Project	IEEE 802.16 Broadband Wireless Access Working Group < http://ieee802.org/16 >	
Title	Clarification on vertically encoded MIMO	
Date Submitted	2005-1-21	
Source(s)	Qinghua Li, Xintian Eddie Lin, Ada Poon, Alexei Davydov, Nageen Himayat, Minnie Ho, Sumeet Sandhu, Uri Perlmutter, Yuval Lomnitz, Randall Schwartz, Jose Puthenkulam Intel Corporation	qinghua.li@intel.com Voice: +1-408-765-9698
Re:		
Abstract		
Purpose	Adoption of proposed changes into P802.16e Crossed-out indicates deleted text , <u>underlined blue indicates new text change to the Standard</u>	
Notice	This document has been prepared to assist IEEE 802.16. It is offered as a basis for discussion and is not binding on the contributing individual(s) or organization(s). The material in this document is subject to change in form and content after further study. The contributor(s) reserve(s) the right to add, amend or withdraw material contained herein.

Clarification on Vertically Encoded MIMO

Figure 3 Proposed structure for vertically encoded MIMO.

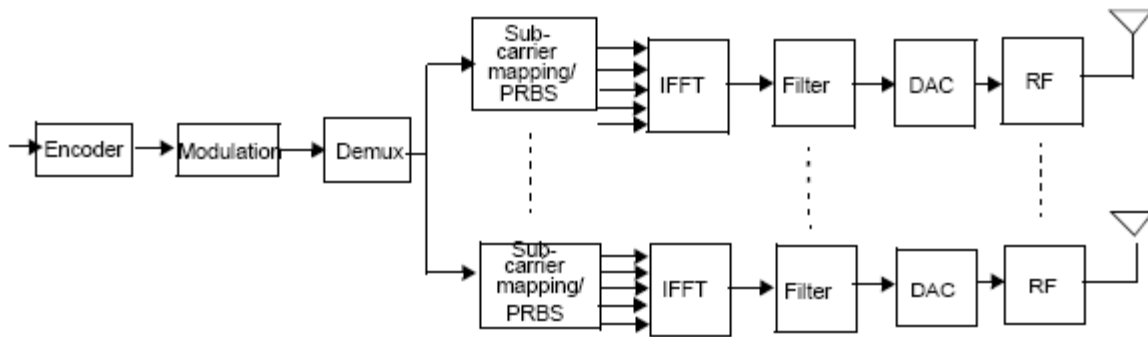
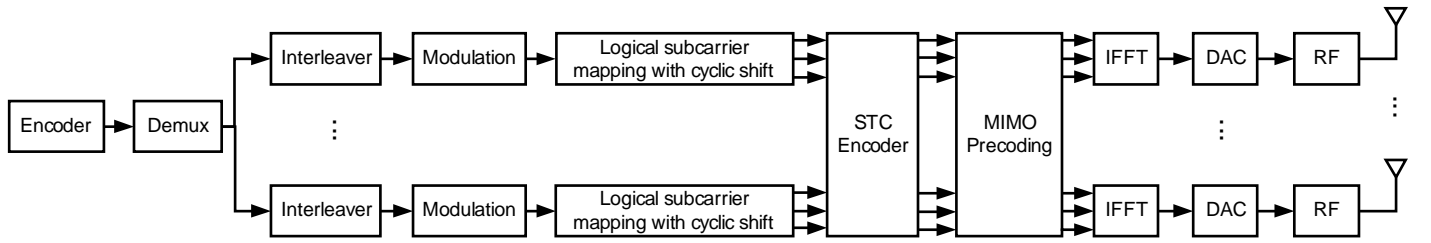
On page 336, D5a, there is an exemplary figure for vertically encoded MIMO, which is shown in Figure 1. The major disadvantages of this structure are as follows. First, new interleavers need to be defined for the increased payload sizes due to parallel spatial channels. For example, the interleaver size at the output of encoder needs to be doubled for two spatial channels. Second, frequency diversity is not maximized because the subchannel allocation for each spatial stream is the same. For example, one FEC block is interleaved and mapped into QAM symbols. The QAM symbols are alternately assigned to two subchannel blocks one per spatial channel by the demux. Because the subchannel allocation is exactly the same on both spatial channels, both subchannels are on the same subcarriers. This means that the FEC block is placed on the same physical subcarriers on both spatial channels. This limitation reduces the frequency diversity if the subchannel doesn't occupy all subcarriers allocated for the user. Frequency diversity can be improved by allowing the logical subchannels on different spatial channels to be placed on different sets of physical subcarriers. Finally, the structure in Figure 1 doesn't support adaptive bit loading because all code bits are mapped to the same modulation constellation before demux. The performance of closed loop is maximized when different modulation orders are employed for different spatial streams. Since the signal qualities on spatial channels can be different by more than 9 dB, which can not be compensated by FEC codes, the weakest spatial channel dominates the performance although there is excess signal power in the strong spatial channels.

We propose slight modifications of the structure in Figure 1. The new structure supports open loop, closed loop, UBL, and ABL, as shown in Figure 3. It doesn't need to define new interleavers for MIMO and employs legacy interleavers designed for single-input single-output systems. The demux in Figure 1 is enhanced to support ABL and a cyclic shift is added at subcarrier mapping block to maximize frequency diversity. The

transmitter works as follows. A block of data bits is first encoded by FEC encoder and the code bits are punctured to achieve a specified code rate. The punctured code bits are distributed to multiple streams according to the modulation orders selected for the spatial channels. It should be noticed that the same modulation order is employed for all subcarrier for a given spatial channel. The distributed bits are interleaved by a legacy interleaver on each channel. The interleaved bits are mapped to QAM symbols and the QAM symbols are mapped to logical subcarriers. The mapped QAM symbols on the logical subcarriers are then circularly shifted by $j-1$ subcarrier for the j -th channel for $j=1, \dots, M$ before they are finally mapped to physical subcarriers. The circular shift allows that the physical subchannel allocations on different spatial channels can be different so that frequency diversity is maximized for the FEC coded block. After the shift, the QAM symbols are STC encoded and may be beamformed. The beamformed symbols are finally mapped to physical subcarriers and are sent by antennas. Detailed description and simulation results of the cyclic shift are in [3]. Detailed operations of the demux are depicted next.

The demux extracts bits for M spatial channels one by one in descending order of the channels' modulation order. It first evenly extracts the bits for the spatial channel with the greatest modulation order from the input bit sequence. Namely, the i -th extracted bit is the k -th bit in the original input bit sequence, where

$$k = \text{round}\left(\frac{i}{L_1} \sum_{j=1}^M L_j\right);$$

M is the number of spatial channels; and L_j is the number of bits on the j -th spatial channel assuming $L_1 \geq \dots \geq L_M$.

Figure 254a Illustration of vertically encoding for optional zones in DL.

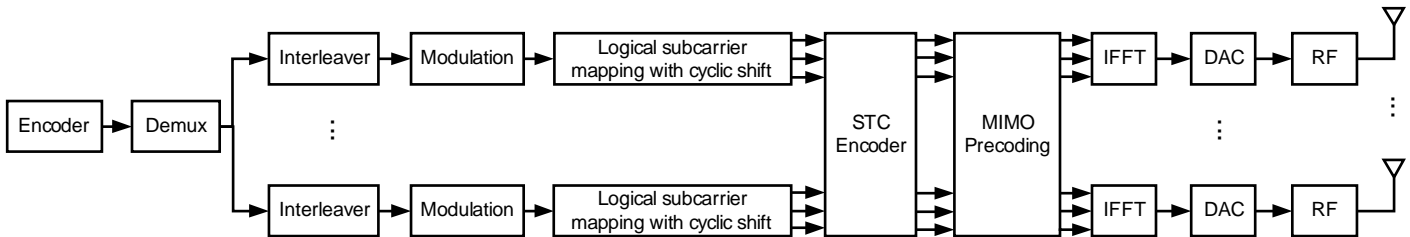
Added section 8.4.8.10 at line 33 on page 362 of [1] as follows

Figure 254a illustrates a transmitter for vertically encoded MIMO, where there are M data streams. The punctured code bits are distributed into M modulation chains by the demultiplexer. The demultiplexer extracts bits for the chains one by one from its input bit sequence. The bits to the chain with higher modulation order are extracted before those with lower modulation order. Denote the number of bits per subcarrier on the j -th chain as L_j , where $L_1 \geq \dots \geq L_M$. The

demultiplexer first extracts the bits for the chain with the greatest modulation order from as follows. The i -th extracted bit is the k -th bit in the original input bit sequence, where $k = \text{round}\left(\frac{i}{L_1} \sum_{j=1}^M L_j\right)$. For the p -th chain, the i -th extracted

bit is the k -th bit in the remaining bits after the extractions for the previous $p-1$ chains, where $k = \text{round}\left(\frac{i}{L_p} \sum_{j=p}^M L_j\right)$.

Each chain interleaves and modulates the distributed bits using the interleaving schemes specified for SISO transmission. After mapped to logical subcarriers, the modulated symbols are circularly shifted by $j-1$ logical subcarriers for the j -th chain for $j=1, \dots, M$. The circularly shifted symbols are then sent to STC encoder.
